Addendum No. 5

Date: April 26, 2013

Reference: Regional Training Institute – TASS Phase 2
Utah National Guard – Camp Williams, Utah
DFCM Project No. 11020480

Subject: **Addendum No. 5**

1 EP101 LEVEL 1 POWER PLAN
1/8" = 1'-0"

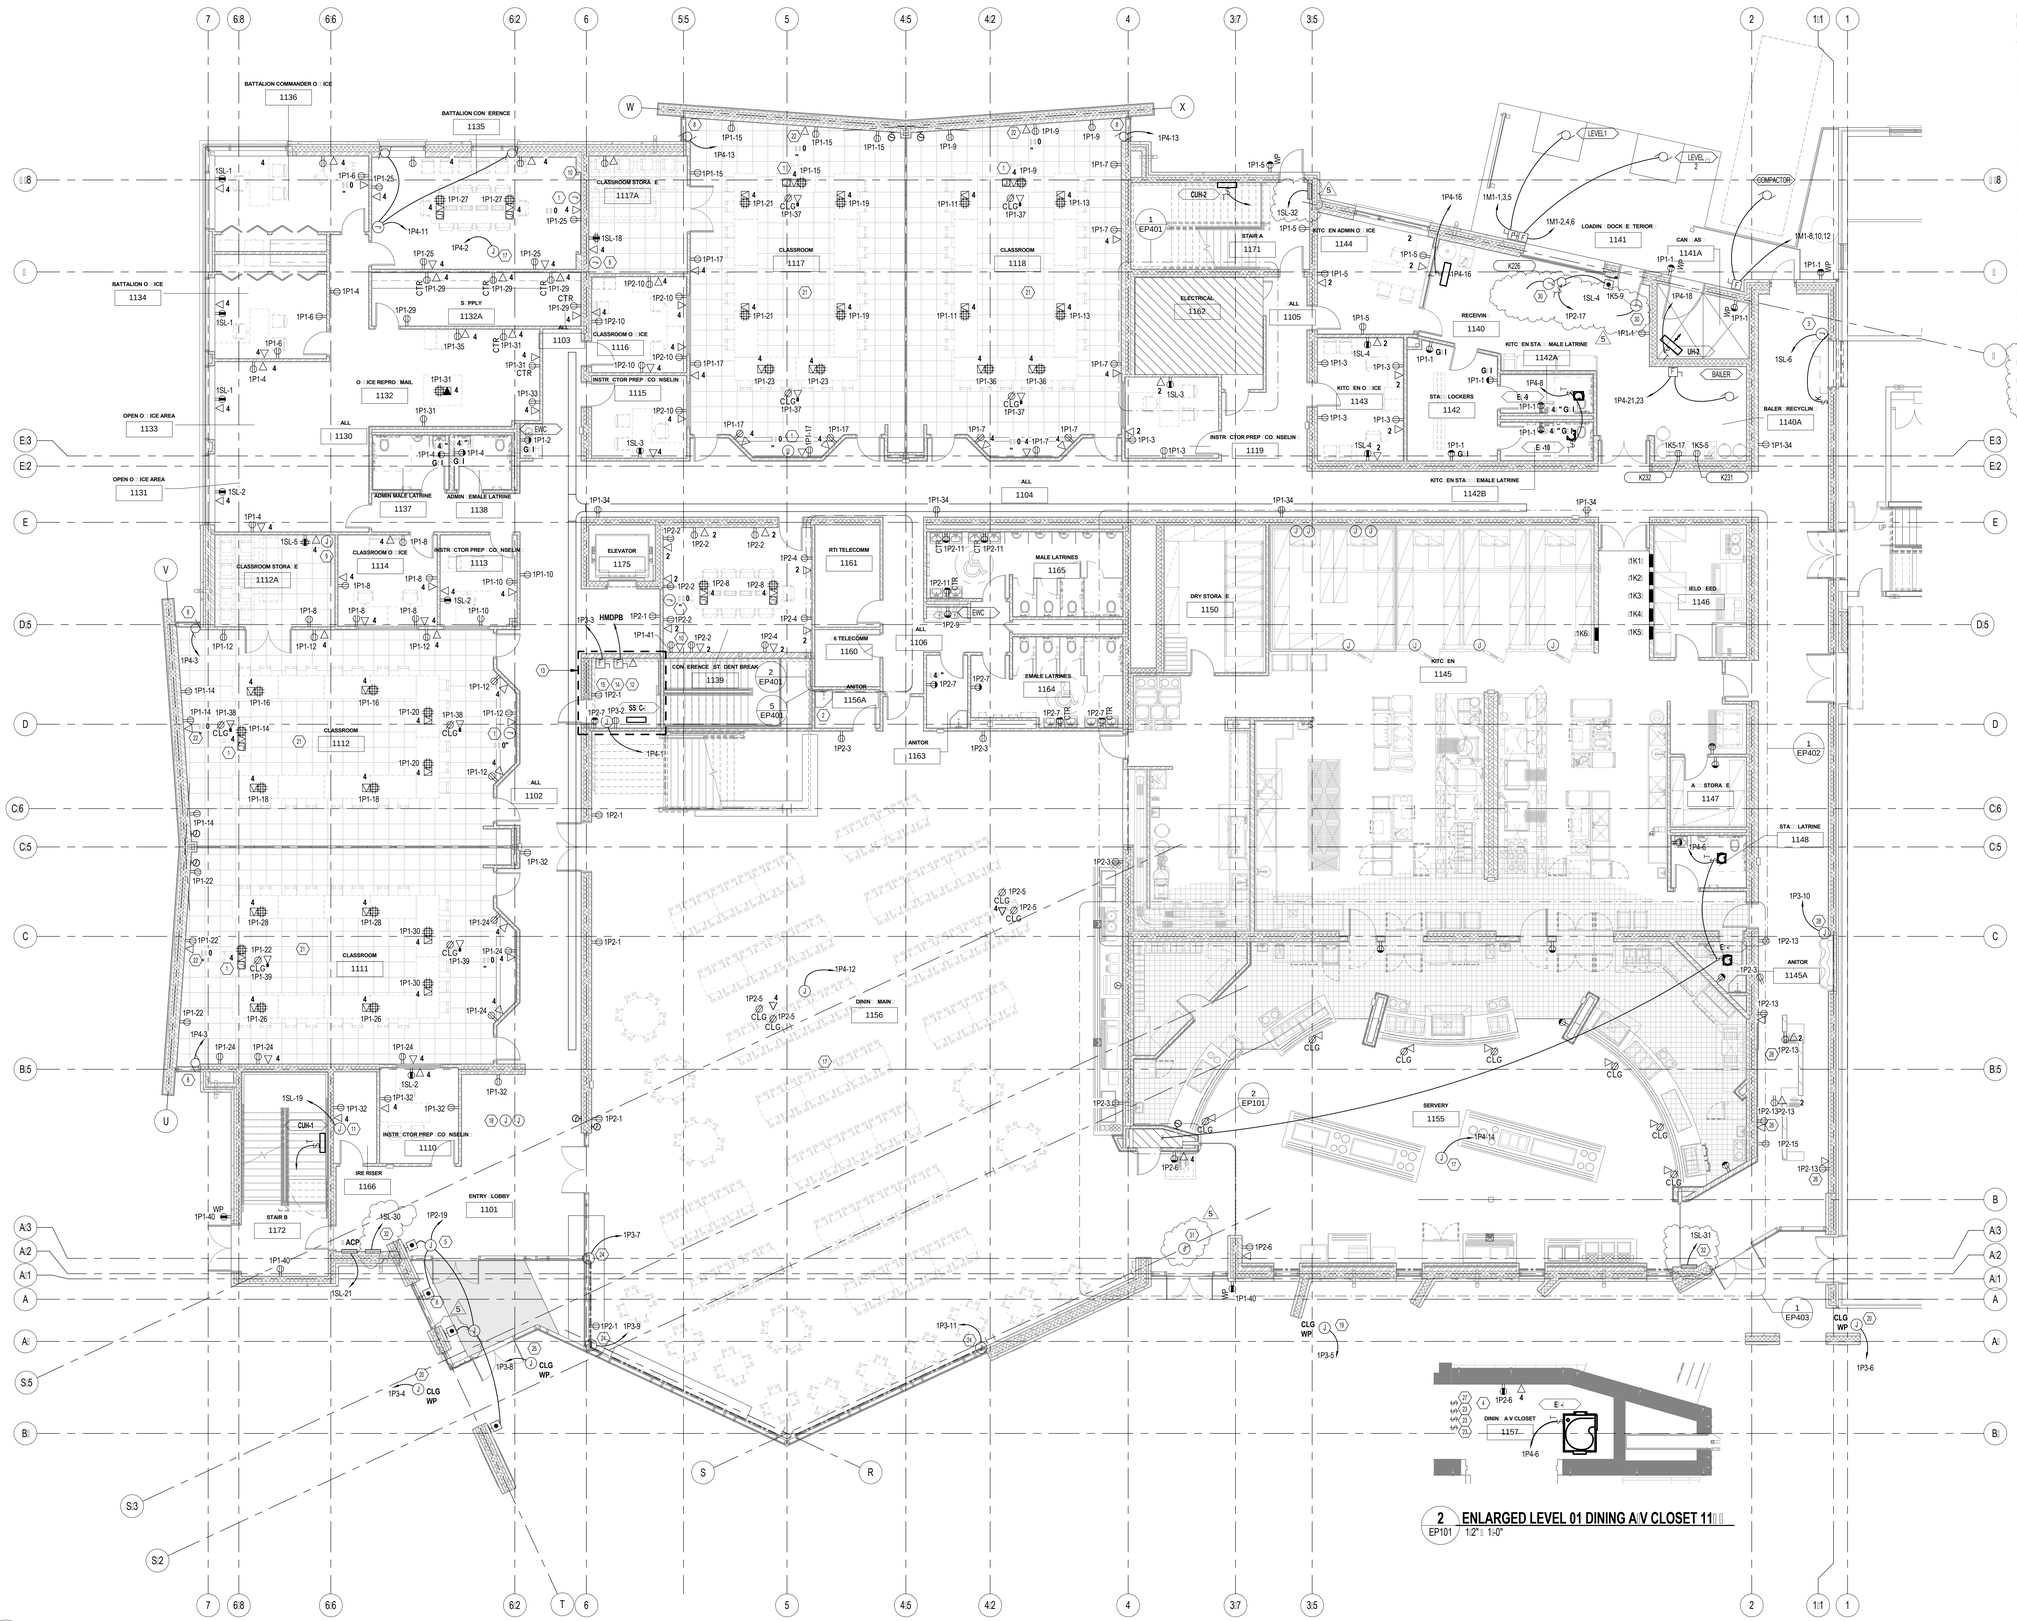
35. Sheet EP101: Note 3 not used.
    a. ***See the attached Memorandum from Engineer, dated April 25, 2013.***

1 ENLARGED ITCHEN 114 POWER PLAN
EP402 1/4" 1:0"

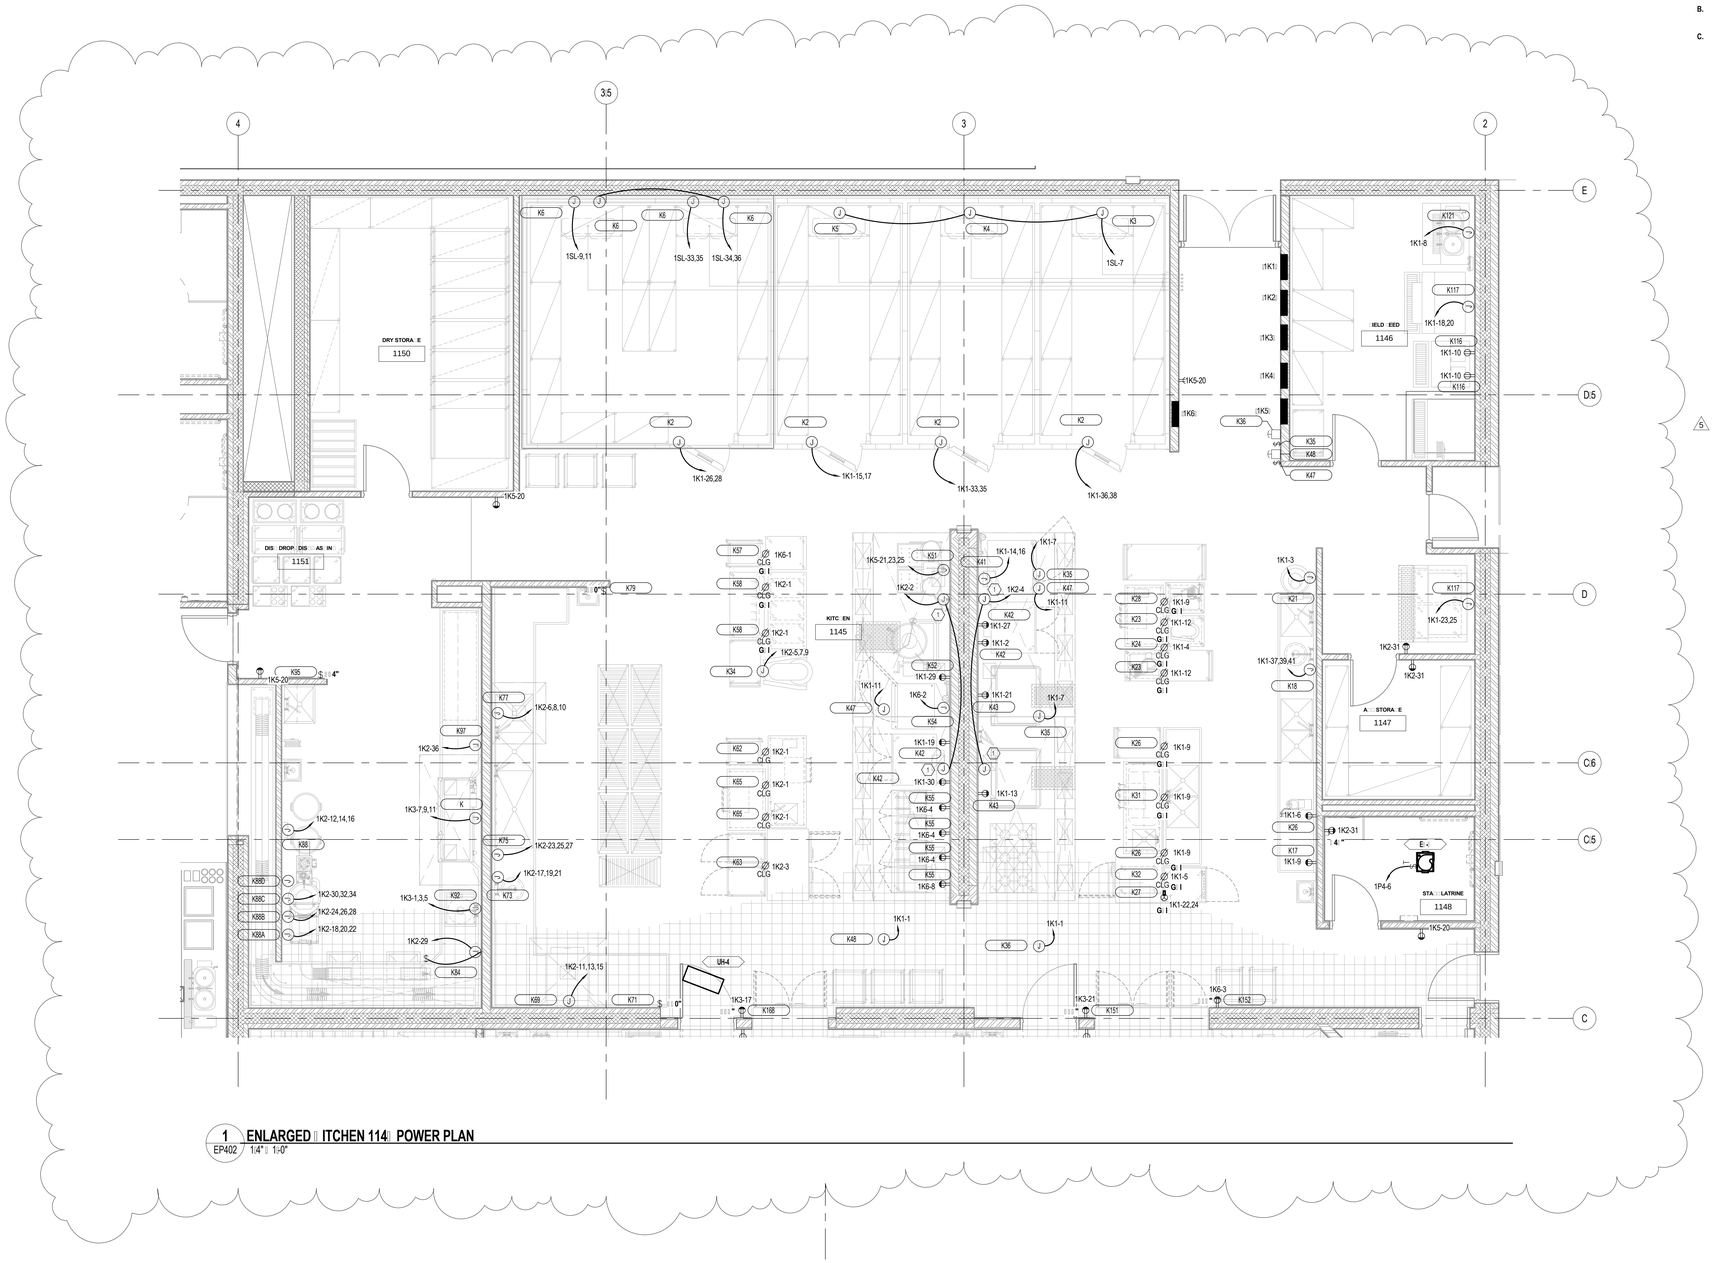
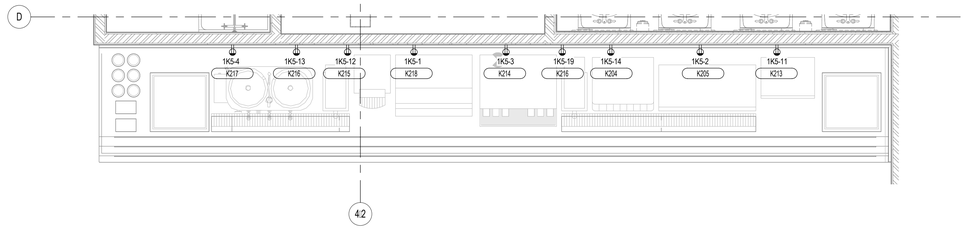
Sheet EP402
5. Delete panels 1E1, and 1E3
6. Delete the UPS and UPS panel 2U1.

4 ROCKY MOUNTAIN POWER
PADVAULT, THREE-PHASE TRANSFORMER
SCALE: NTS

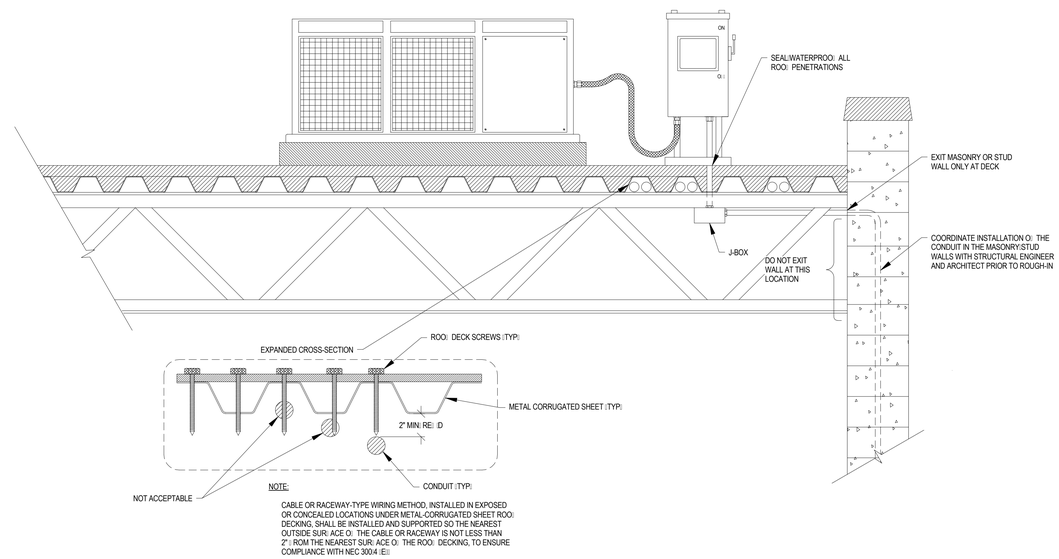
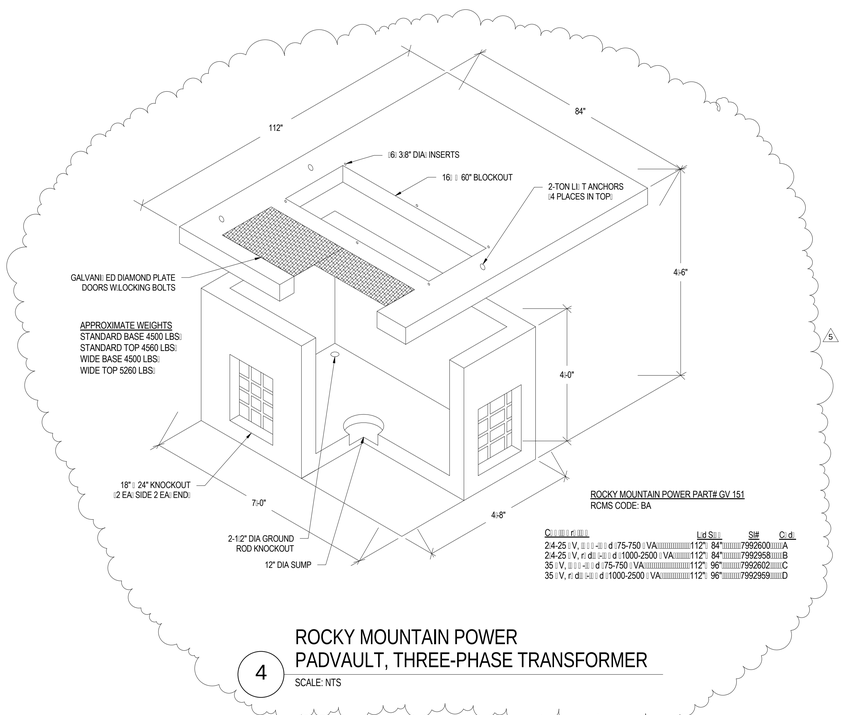
36. Sheet EP501: Where is detail 2 applicable?
    a. ***See the attached Memorandum from Engineer, dated April 25, 2013.***

37. Sheet EP501: Conflict Detail 4 - transformer pad where is it applicable, sheet EP600 note 10 indicates a pad vault at each transformer, which is correct?
    a. ***See the attached Memorandum from Engineer, dated April 25, 2013.***

1. *Where is detail 2 applicable?*
   KGE RESPONSE: WE have now fixed that detail so it is now a pad/vault.
2. *Conflict Detail 4 - transformer pad where is it applicable, sheet EP600 note 10 indicates a pad vault at each transformer, which is correct?*
   KGE RESPONSE: The transformer pad vault is correct. The detail for the pad has now been replaced with a pad/vault.

1 ADMIN. BUILDING ONE-LINE DIAGRAM
EP601 SCALE: NTS

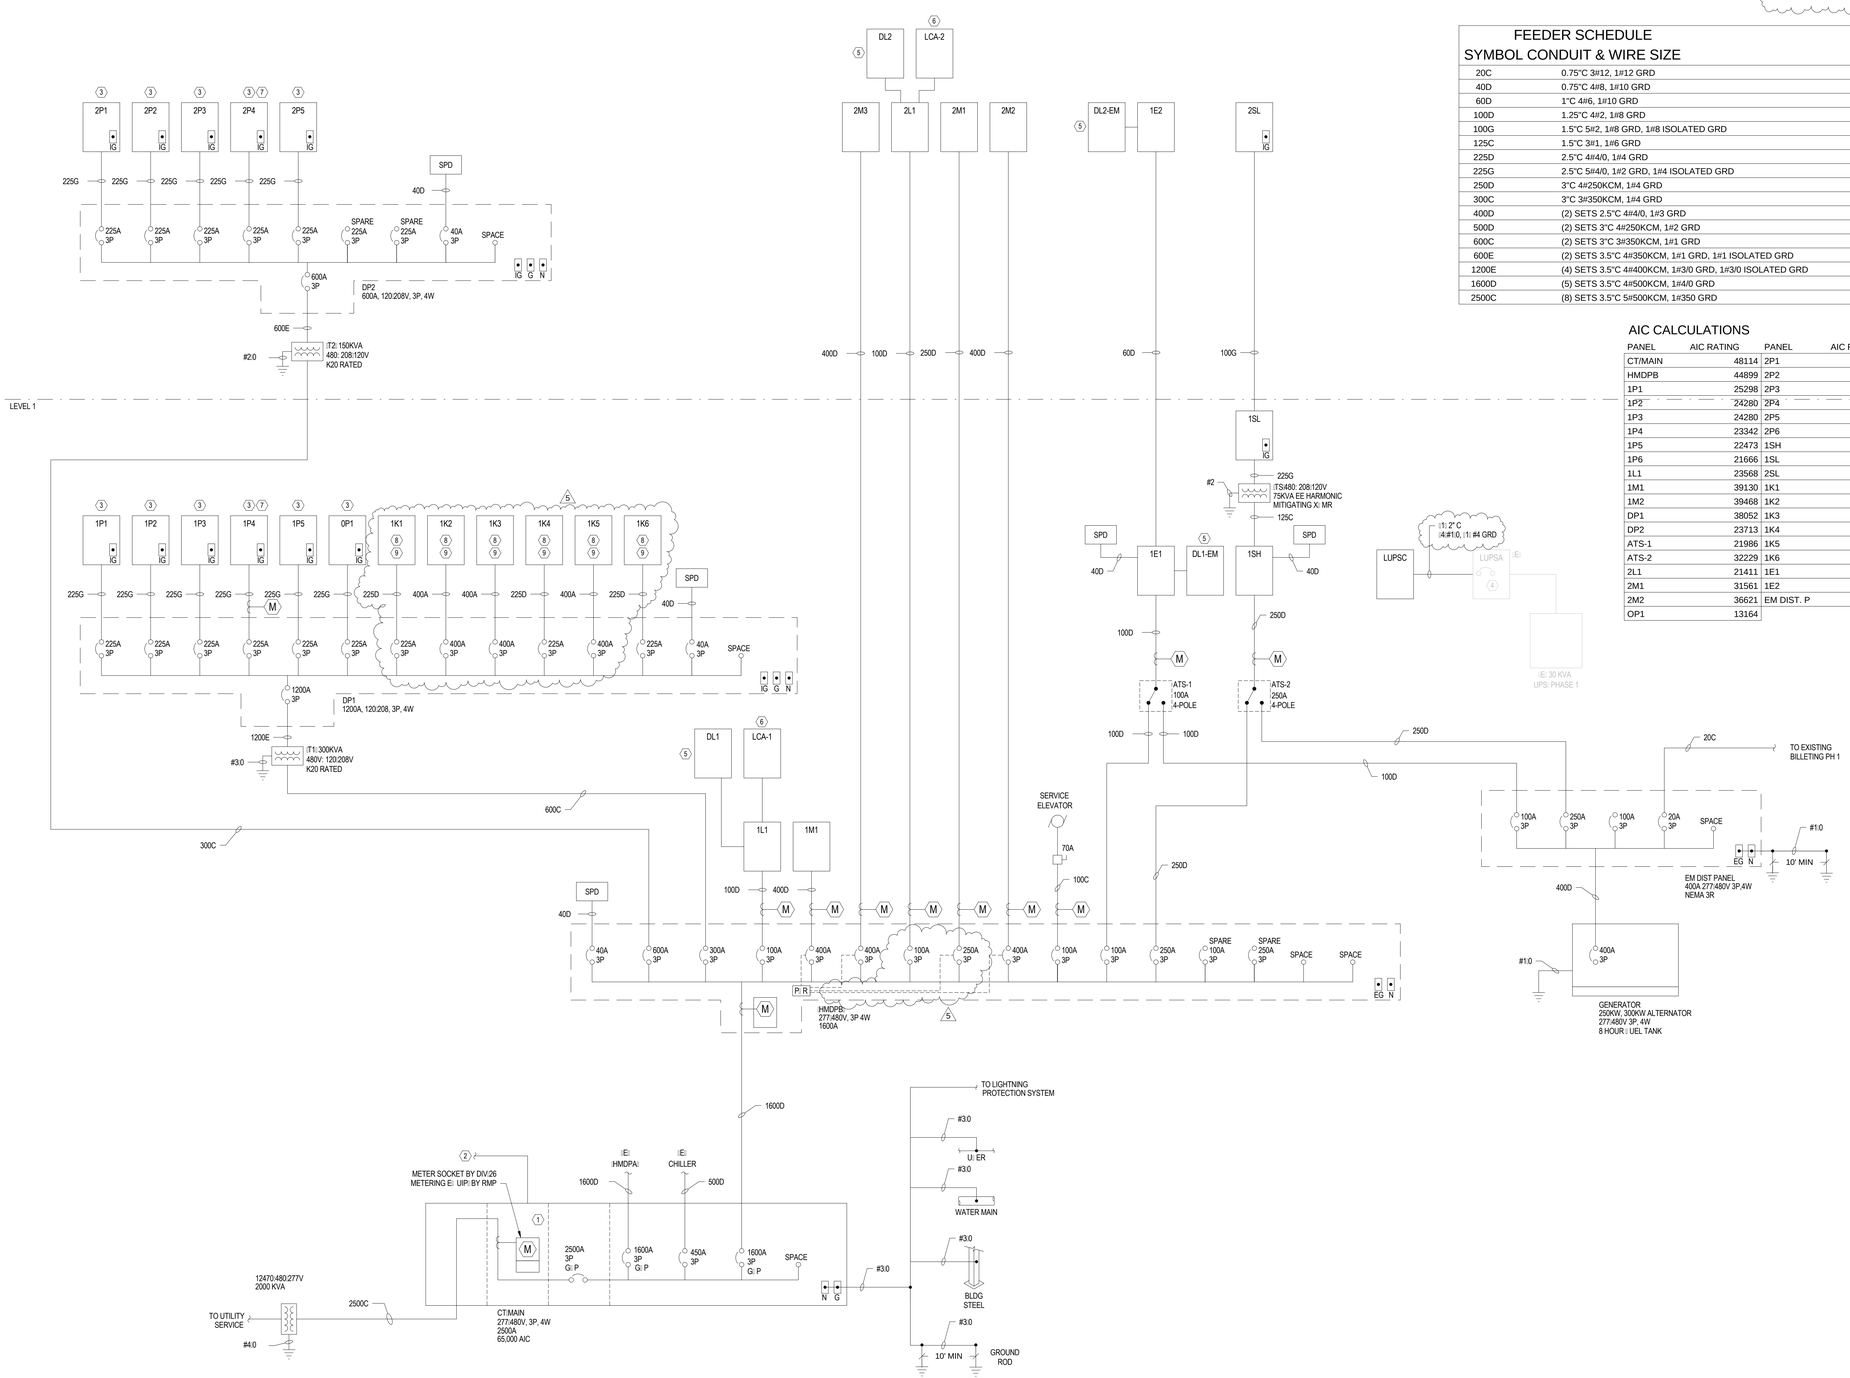
38. Sheet EP601: CT/Main fees (e) chiller, where is the equipment located? Routing of conduits.
    a. ***See the attached Memorandum from Engineer, dated April 25, 2013.***

39. Sheet EP601: Panel 2L1 is feed with 250 Amp breaker, feeders are rated 100D
    a. ***See the attached Memorandum from Engineer, dated April 25, 2013.***

40. Sheet EP601: Panel 2M1 is feed with 100 Amp breaker, feeders are rated 250D
    a. ***See the attached Memorandum from Engineer, dated April 25, 2013.***

41. Sheet EP601: Panel LUPSA to LUPSC note 4 is indicated as existing? Feeders show #10s for a 100Amp service?
    a. ***See the attached Memorandum from Engineer, dated April 25, 2013.***

42. Sheet EP601: Do DL1, DL2, DL1-EM, DL2-EM, LCA-1, LCA-2 need power circuits? Please indicate?
    a. ***See the attached Memorandum from Engineer, dated April 25, 2013.***

43. Sheet EP601: Please give location of LCA-1 and LCA-2 not shown?
    a. ***See the attached Memorandum from Engineer, dated April 25, 2013.***

44. Sheet EP601: Note 2 indicate cat 5 to IDF does this correspond to the 260913-2.4 requirements? Do the other 9 meters shown need to be monitored in this manner?
    a. ***See the attached Memorandum from Engineer, dated April 25, 2013.***
